Water Resources Department

1. Mount Scott Water District - production well (start card number 95211)
2. Mount Scott Water District - piezometer well (start card number 87136)

RE: Special Standards for Mt. Scott WD

REQUEST FOR WRITTEN APPROVAL TO USE CONSTRUCTION METHODS INCLUDED IN OREGON ADMINISTRATIVE RULES 690-200 THROUGH 690-240 WATER RESOURCES DEPT SALEM, OREGON

Mt. Scott W.D. Test Well - S.C. #87136

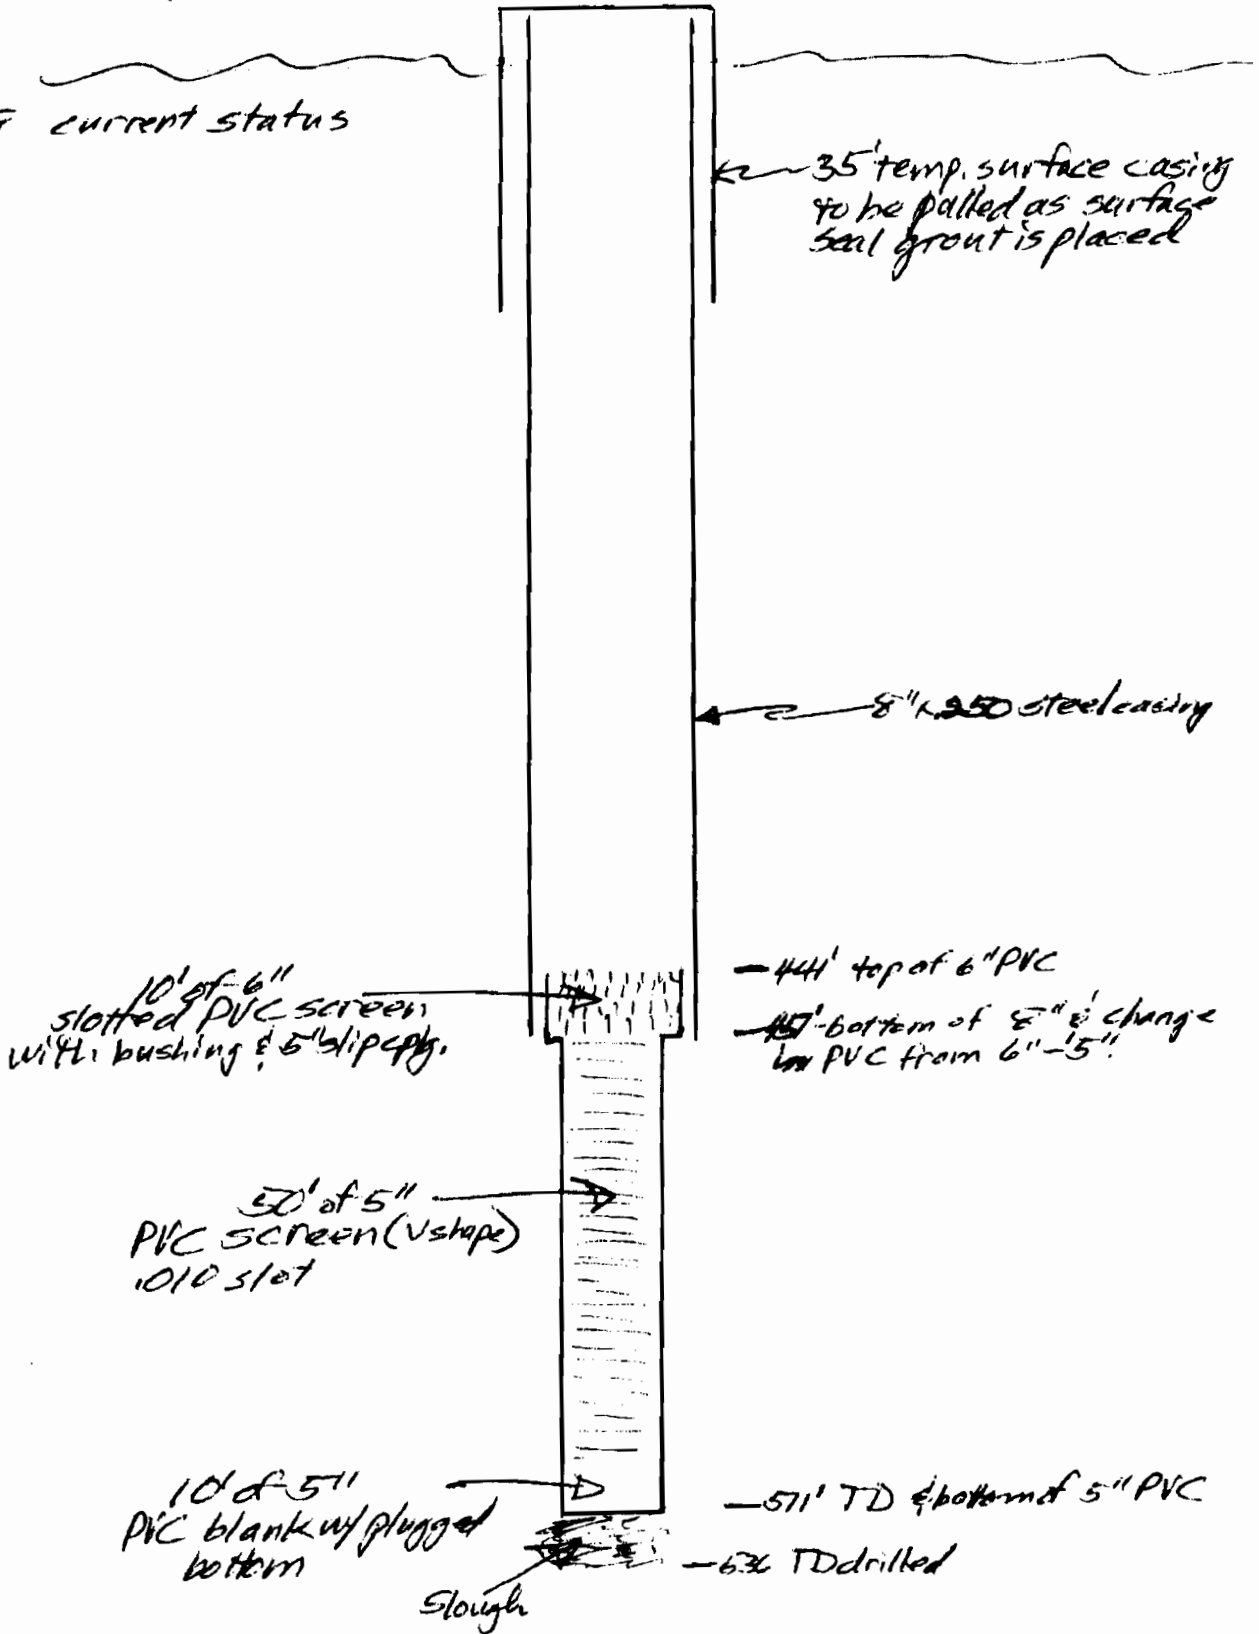
Basically the 8" casing will be abandoned by perforating
(4 row rotary) and then grouting almost full depth
after 4" casing installation. See attached sketches
of before and after.

8" casing to have water injected continuously to prevent slough at start of perforating until grouting is completed (or at least up in top 60' of hole)

4 rows of air rotary perforations in 8" casing from top to w/30'. Grout to pumped thru flush OD tremie from bottom to top. Initial grout placement of calculated minimum 10 annulus volume will be allowed to set prior to additional grouting to minimize risk of getting grout in aquifer.

Mt. Scott W.D. Test Well - S.C. #87136

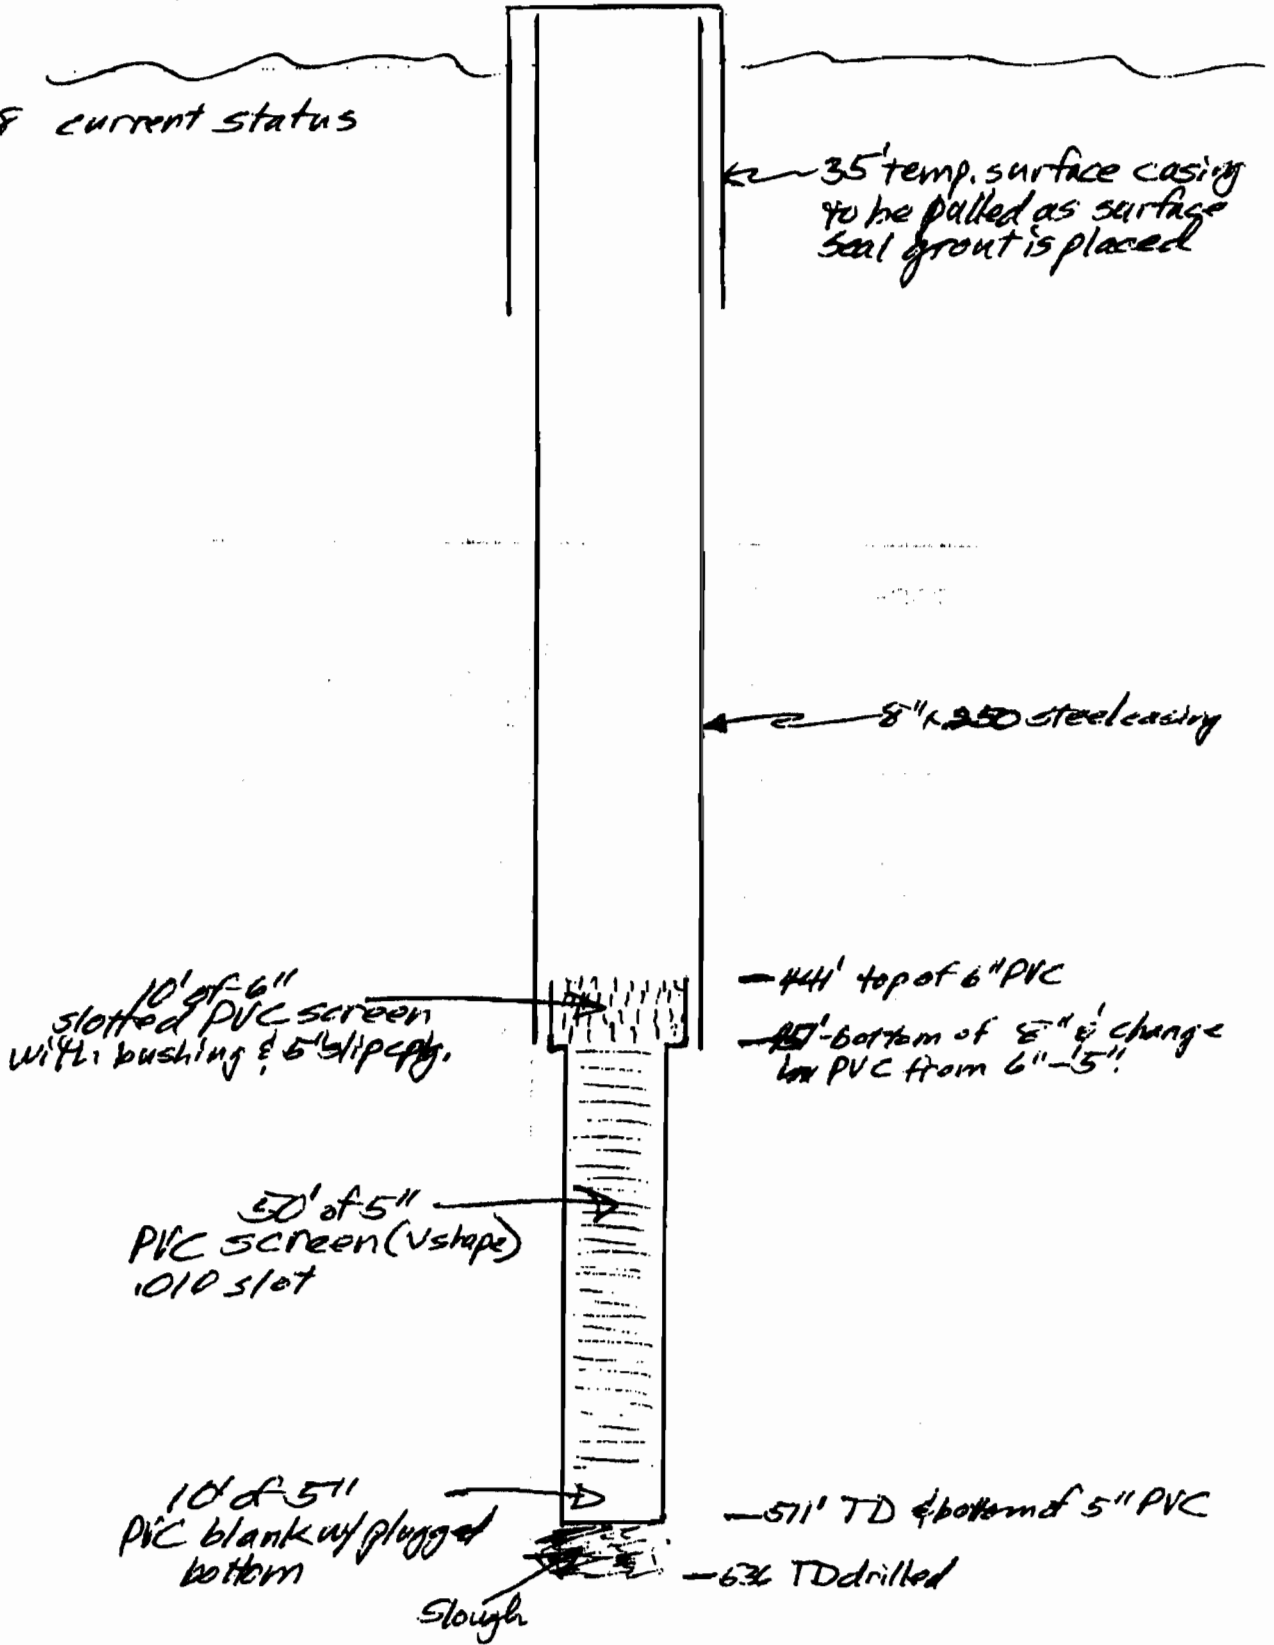
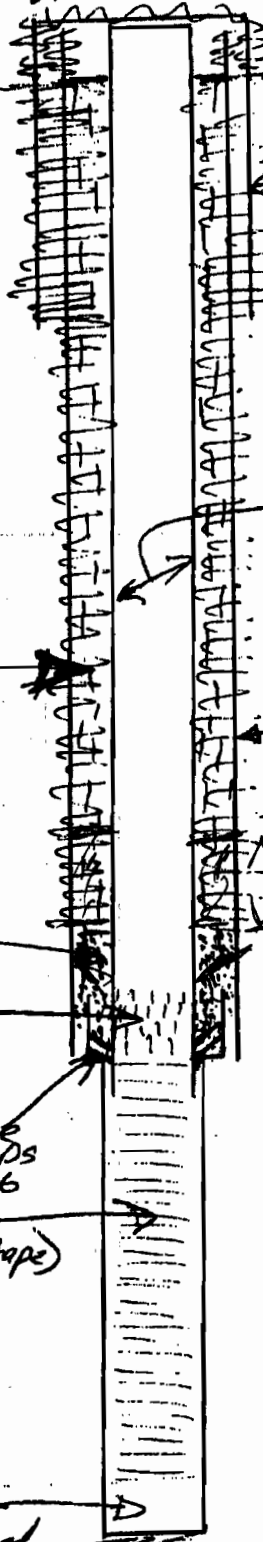
Attached is a sketch of the well's current construction and a sketch of the proposed completion in addition to the formation log. I'll see you this afternoon to discuss.

air rotary perforations
in 8" from top to ~430'
with grout pumped thru
1" frame from bottom to top.

10' plug.
approx 430' - grout/sand interface

cast 10 x 20
sand backfill to prevent
downward grout migration
10' of 6"
slotted PVC screen
with bushing & 5" slip cap.

ATTACHMENT II

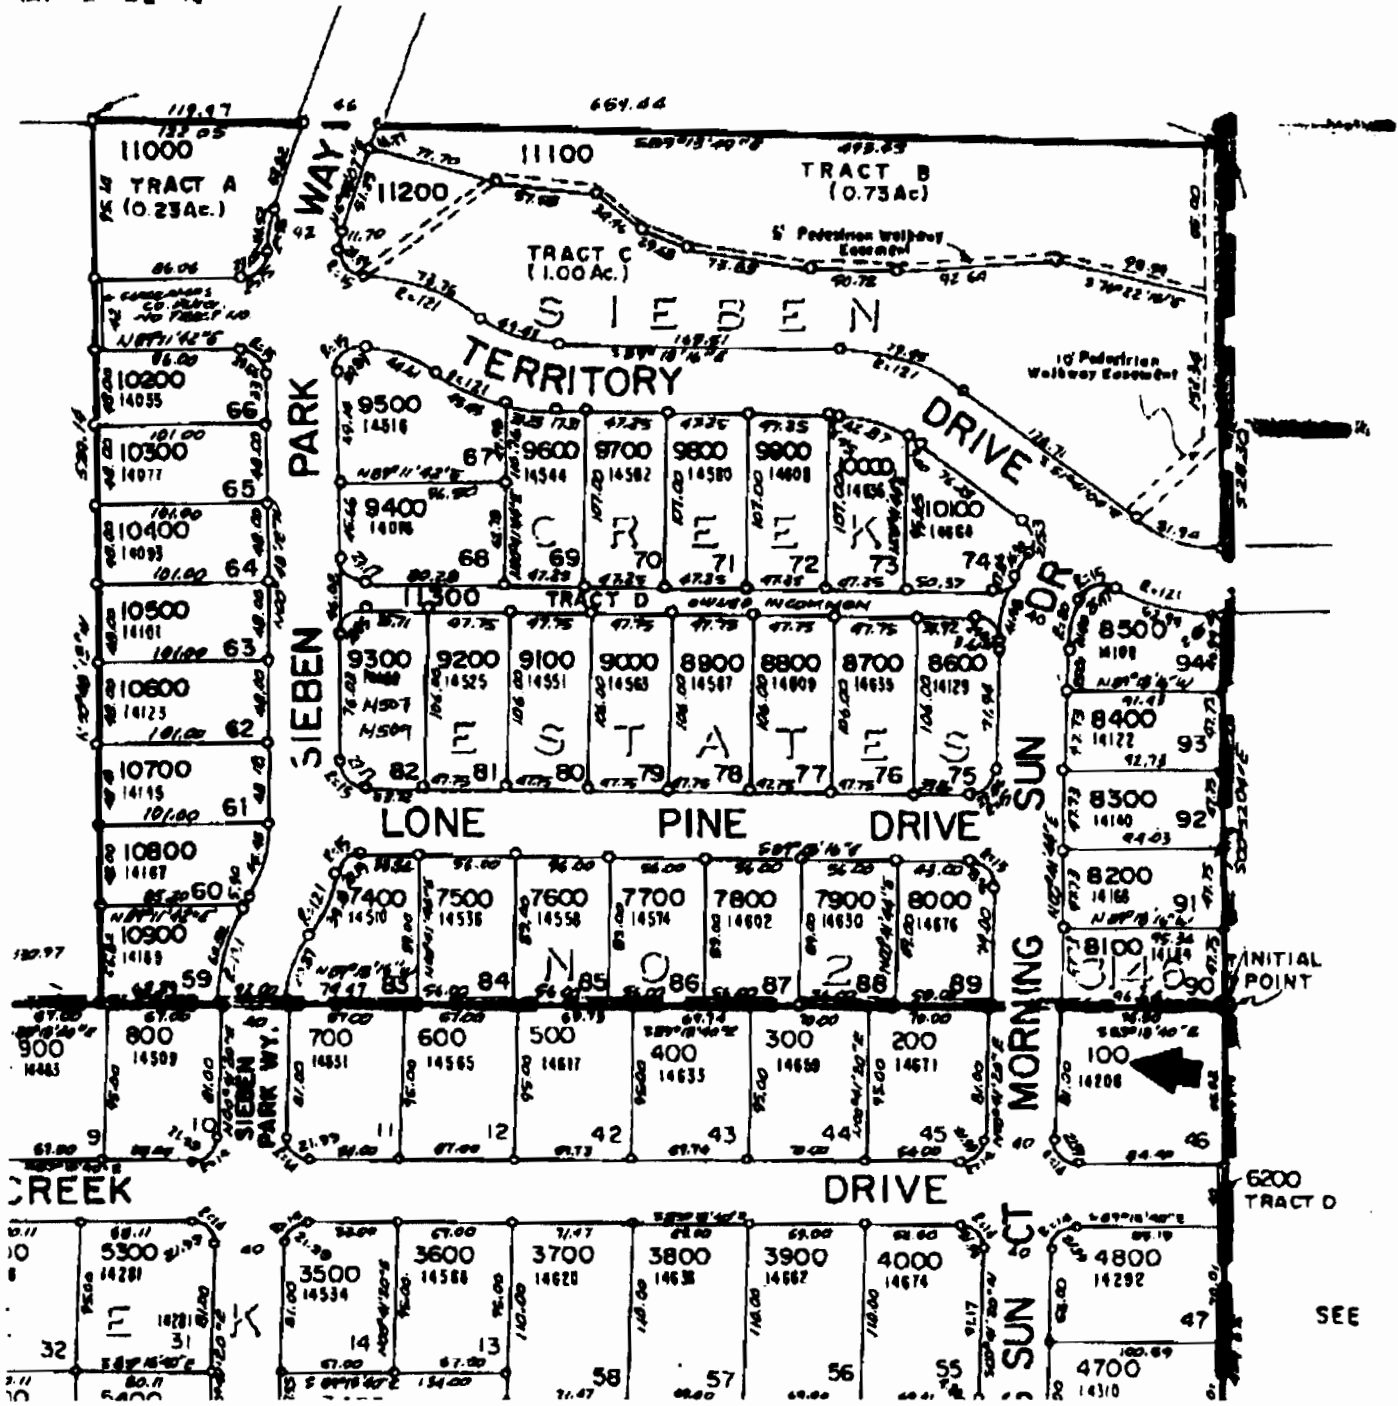
The Mt. Scott Water District has recently discovered that a Clackamas County sewer line runs within 30 feet of the new well Schneider Equipment has been drilling for the District (see Attachment I). Before the drilling began, Mt. Scott staff requested utility locates and reviewed a Clackamas County Assessor's map, of which neither showed a sewer line cutting through the North Clackamas County Parks and Recreation property. The Assessor's map only shows a 10 foot pedestrian walkway easement (see Attachment II), but it does not show an easement for a sewer line. The locates only indicated a sewer line running along the eastern edge of the Park's property. Given the locates and County information, the well was located so that it would be at least 50 feet from the sewer line.

While completing the design for the pump vault, the District discovered a sewer line closer than the 50 foot designation. It is our understanding that you will be requesting a waiver from the State Water Resources Department for the 50 foot setback requirement based on your well casing design for the project. Please keep us advised as to the outcome.

Recent information obtained by the District indicates the presence of a sanitary sewer line within 50 feet of this well. It is anticipated that this well will be sealed extensively into the basalts at approximately 450 feet below land surface. Given this type of construction, your request is approved with the following conditions:

1. The well must be continuously sealed to a minimum of 200 feet or 25 feet into the basalt rock overlying the target aquifer.
2. The District must be informed that this well is located within the minimum setback distances and that frequent water potability testing is recommended.
